British Kart  
Championships

**IAME, Bambino & Honda**  
**Larkhall 18-20 August 2023.**

**Event Bulletin 03 - Technical**

**Alternative Rain Cover IAME X30 Junior & Senior**

RAIN COVER FOR ALTERNATIVE INLET SILENCER – DRAWING

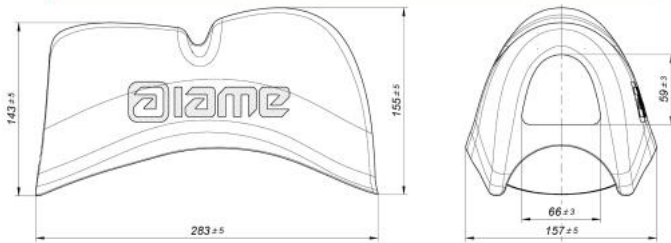
In addition to the above inlet silencer there is an option to use an alternative component the details of which are listed below.

IAME UK have confirmed that with immediate effect the old unit has now been discontinued and replaced with the item below - see page 2:

THIS RAIN COVER TO USE ONLY FOR ALTERNATIVE INLET SILENCER  
(Appendix 21)
